ADDENDUM TO BASIC ASSESSMENT AS REQUESTED BY KZN DEPARTMENT OF AGRICULTURE & ENVIRONMENTAL AFFAIRS

FOR THE PROPOSED WOODBURN BOULEVARD
SHOPPING CENTRE ON THE CORNER OF
WOODHOUSE AND ALAN PATON DRIVE (ON
PORTION 5 OF ERF 4346, PIETERMARITZBURG)

DECEMBER 2013- DC22/0059/2011

RE: DC22/0059/2011: REJECTION OF THE BASIC ASSESSMENT REPORT FOR THE PROPOSED WOODBURN BOULEVARD SHOPPING CENTRE ON THE CORNER OF WOODHOUSE AND ALAN PATON DRIVE ON PORTION 5 OF ERF 5346, LOCATED WITHIN PIETERMARITZBURG, MSUNDUZI MUNICIPALITY

ORIGINAL APPROVED SDP

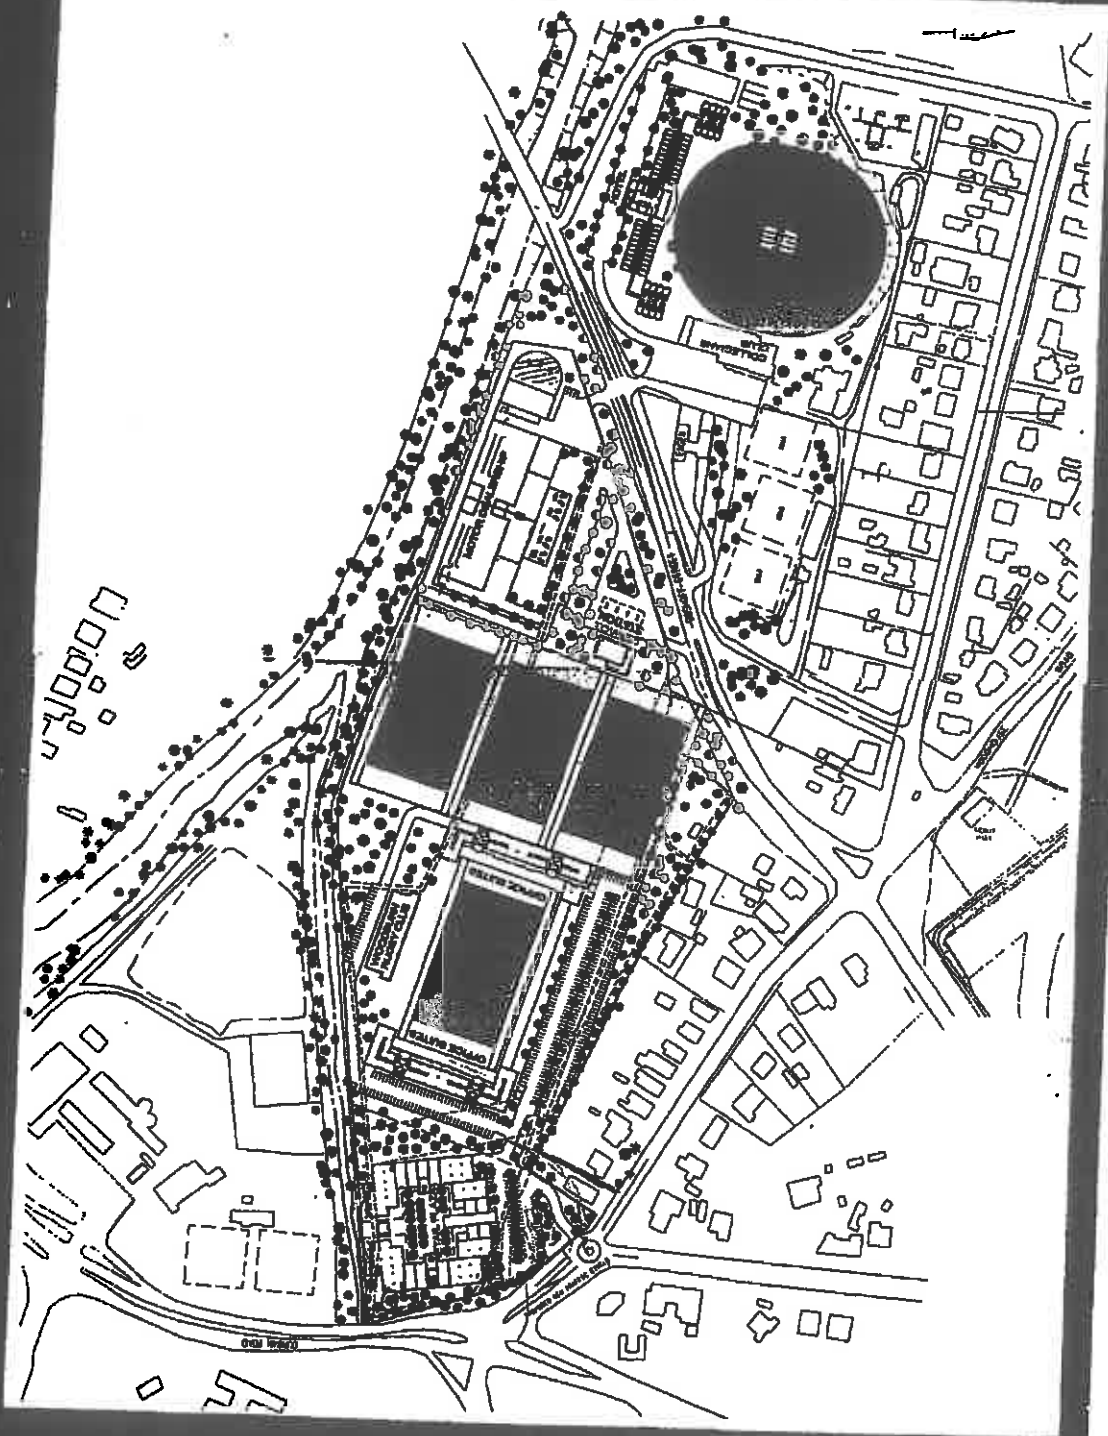
Kindly provide this Department with a full copy (including layouts etc.) of this approval for reference purpose and to ensure consistency in respect of access points and layout etc."

Please find attached hereto **(as Appendix D)** a copy of the DFA approval as supplied to us by the local authority.

Figure 4-6 The 1:50 Year Floodlines for the Proposed Woodburn Development

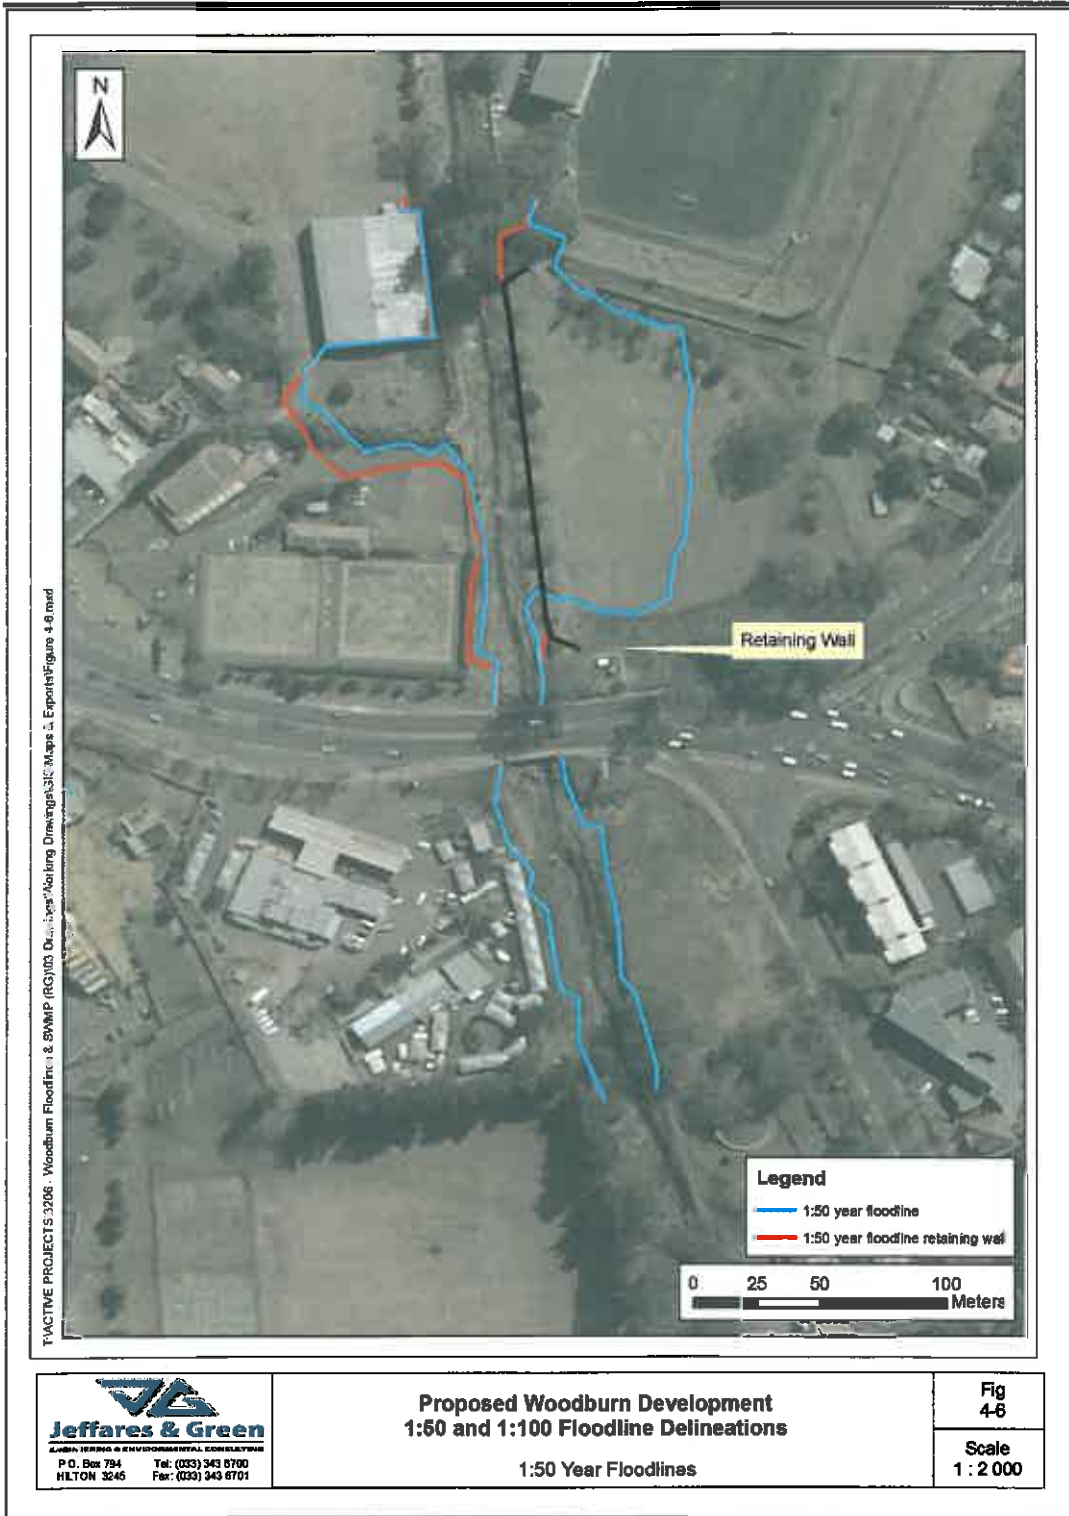
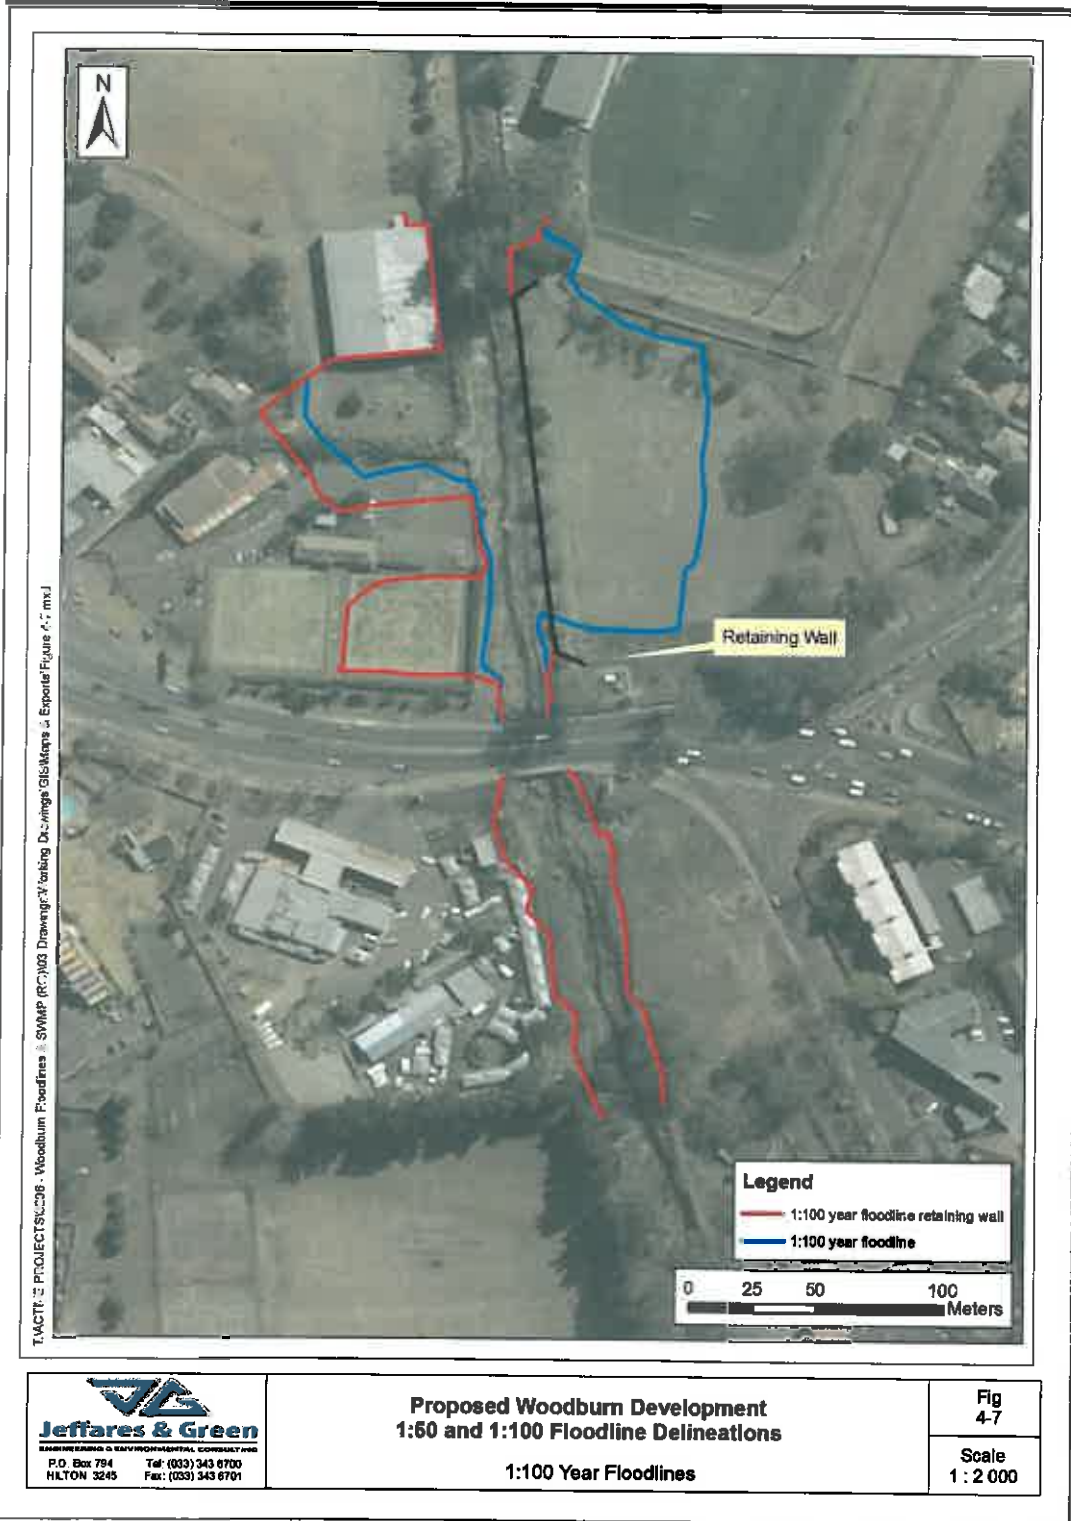
- *"The site layout plan must be revised to illustrate the 1:50 and 1:100 year floodlines of the proposed development site and submitted to this Department for approval. The Ground Floor Plan (prepared by Boogertman and Partners and dated April 2000) included as Appendix A of the BAR (prepared by Bokamoso Landscape Architects and Environmental Consultants and dated April 2013) must be used as a baseline for the site layout plan template and revised with reference to the layout plan included as Appendix B of the Stormwater Management Plan and Floodline Delineation Report (prepared by Jeffares and Green consulting engineers and undated)."*

Refer to Appendix F
